***Environmental Assessment – 10 Megawatt Wind Power Project,
Lingan Addendum***

Dillon Consulting Limited, on behalf of Glace Bay Lingan Wind Power Limited (GBLWP), has prepared the following addendum to the above environmental assessment in response to the June 5, 2006 letter requesting additional information on the project

Figure A-1
Infrastructure Map

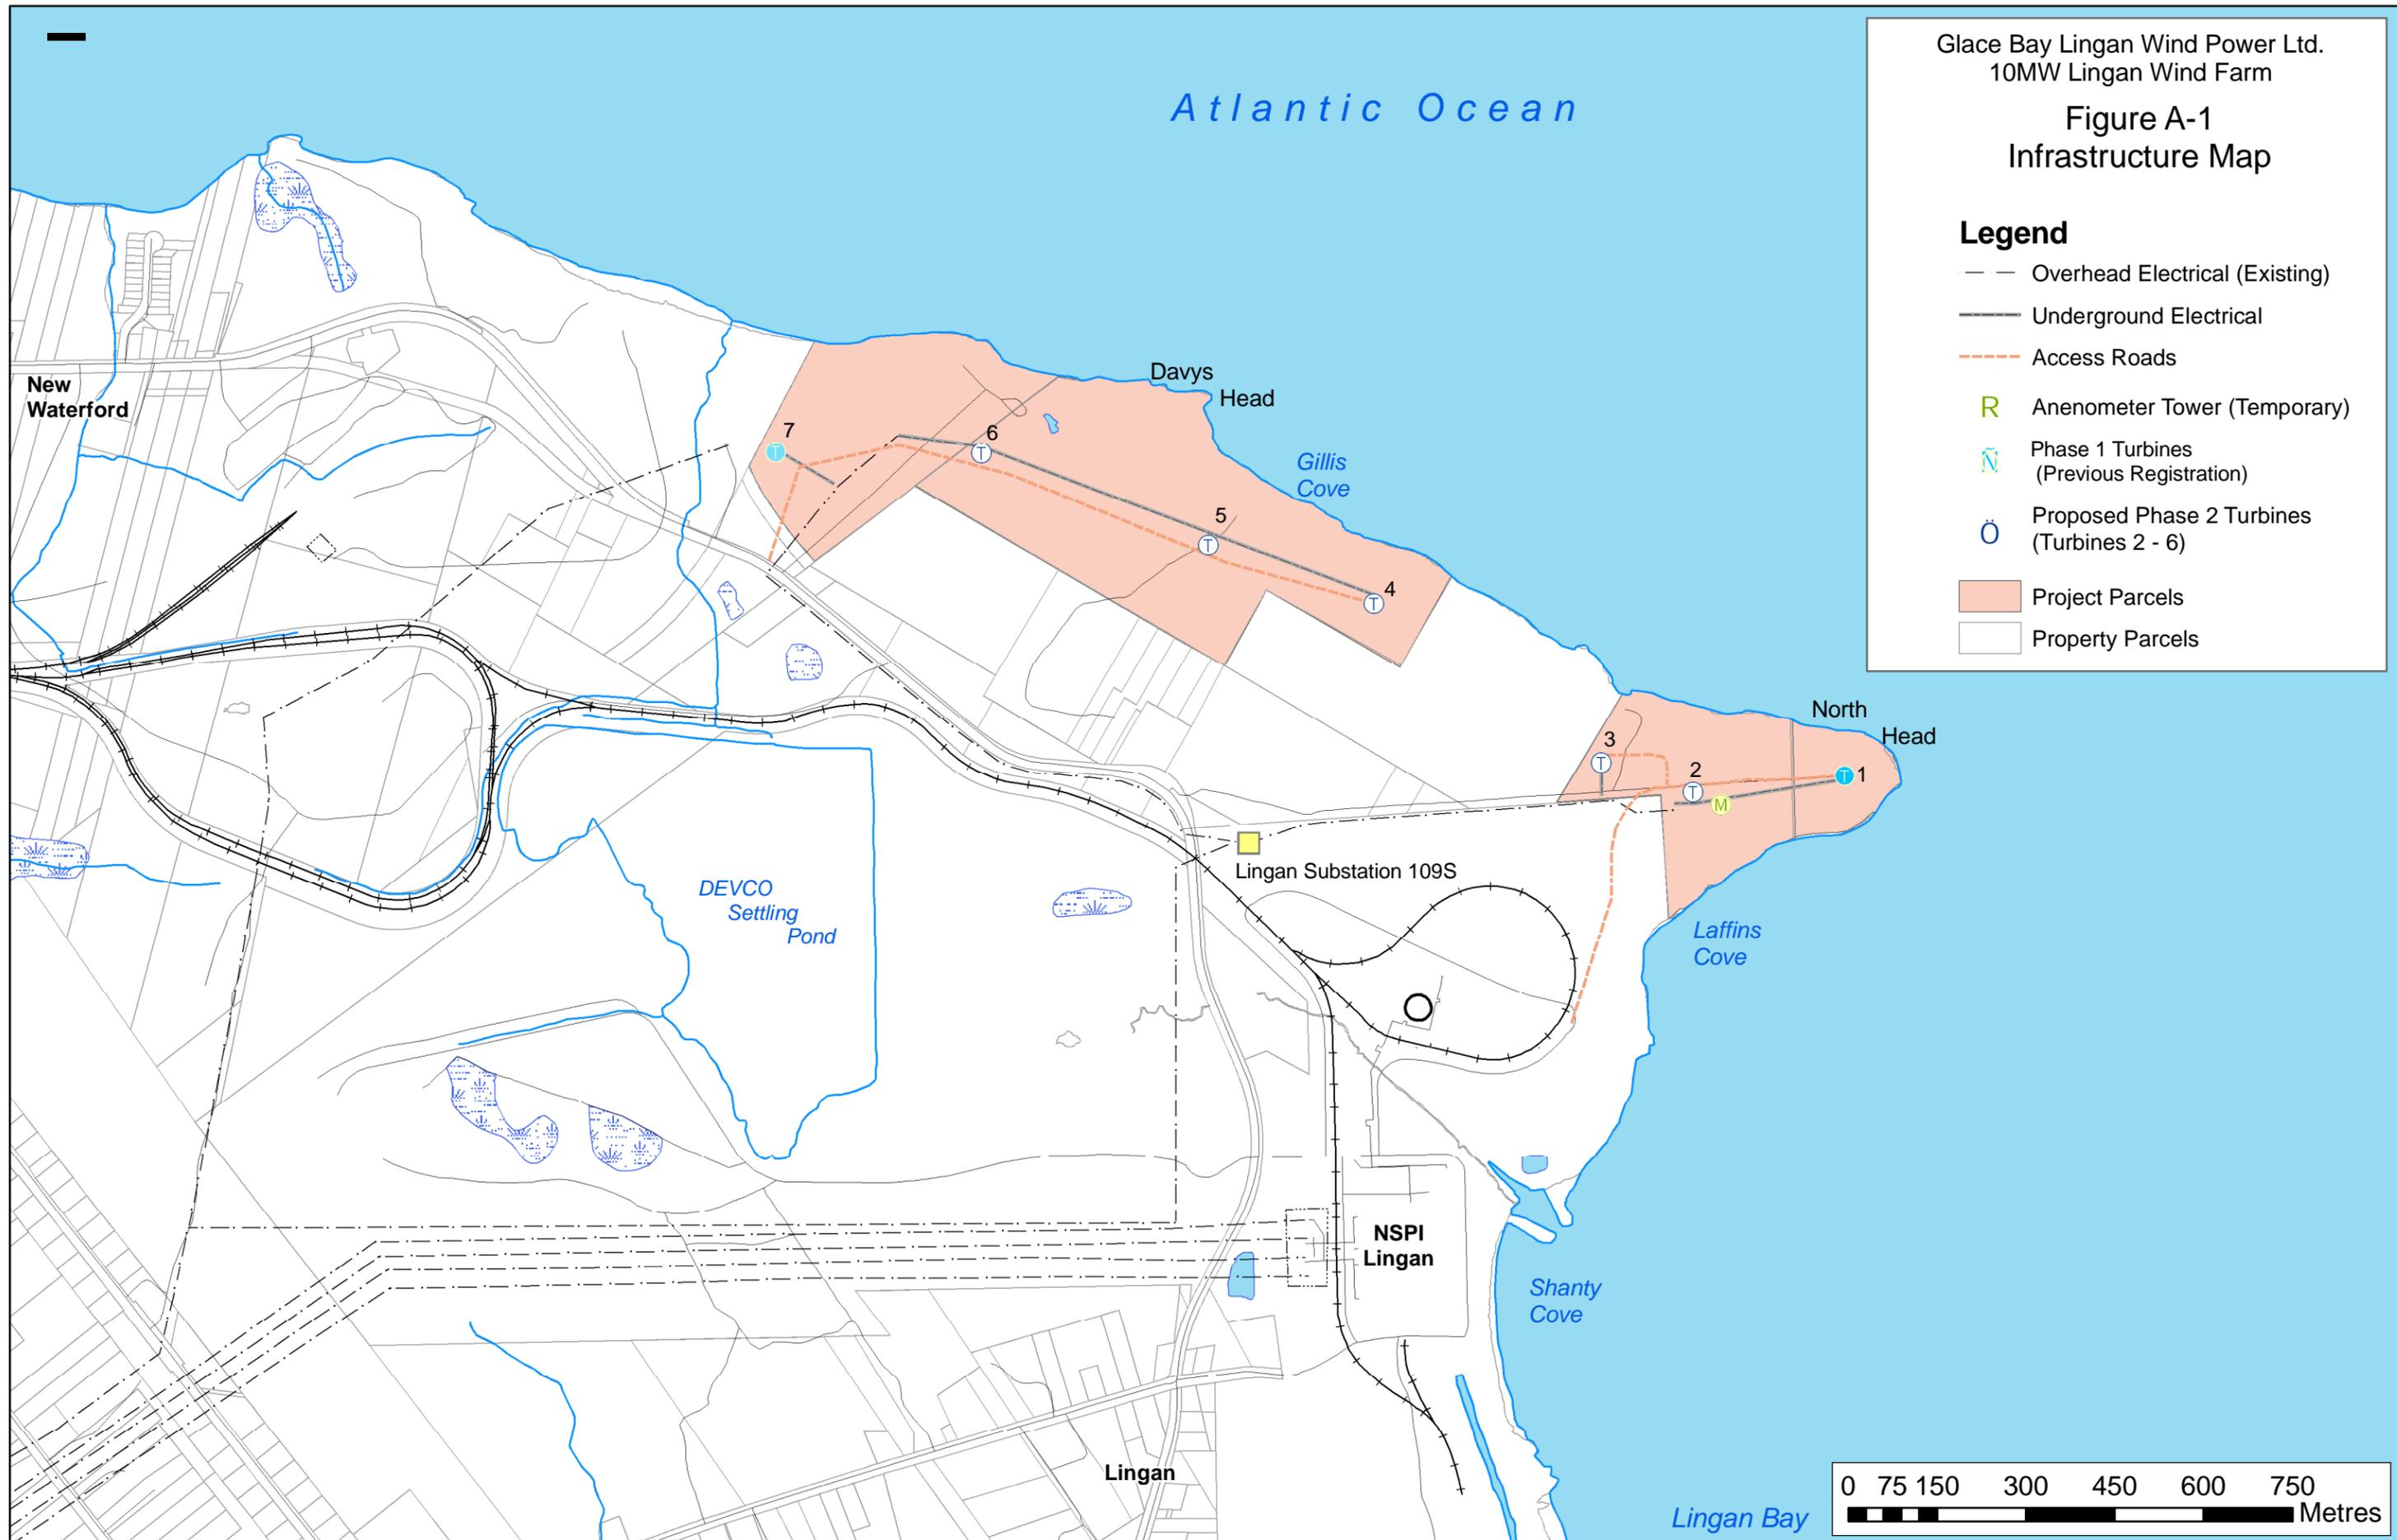
Glace Bay Lingan Wind Power Limited shall provide a map(s) and a written description of the basic project details. This should include, but not be limited to: the proposed location of the five turbines, 1.6 km access roads, interconnecting cables, and connection to the Nova Scotia Power grid.

The facility will consist of five 2 MW wind turbines constructed between Hinchey Avenue and the shoreline. The turbines will be connected to the NSPI grid at Lingan. The area of the site chosen for the wind farm is approximately 44.8 ha. The proposed locations of the turbines and associated infrastructure are shown in Figure A-1.

The turbines will be connected by approximately 1.6 km of cables that will be buried approximately one metre below the surface. The anticipated location of these cables is shown in Figure A-1. Each turbine has its own transformer that will raise the current to a distribution level voltage of 25 kV. Each transformer has its own catch basin and spill containment. The individual turbine transformers are connected via cables to a main transformer/substation that raises the voltage to 69 kV for interconnection with the NSPI grid. Interconnection will occur at the Lingan 109S substation (Figure A-1). The substation transformer has its own containment system with oil/water separator.

GBLWP will construct approximately 1.6 km of roads to access the site and to connect the turbines (Figure A-1). The all season roads will be constructed on the lands wholly owned by GBLWP and in accordance with our EPP. The maximum slope of the access roads will be no greater than 6%. The roadbed will be constructed to permit a maximum axle load of 12 tonnes.
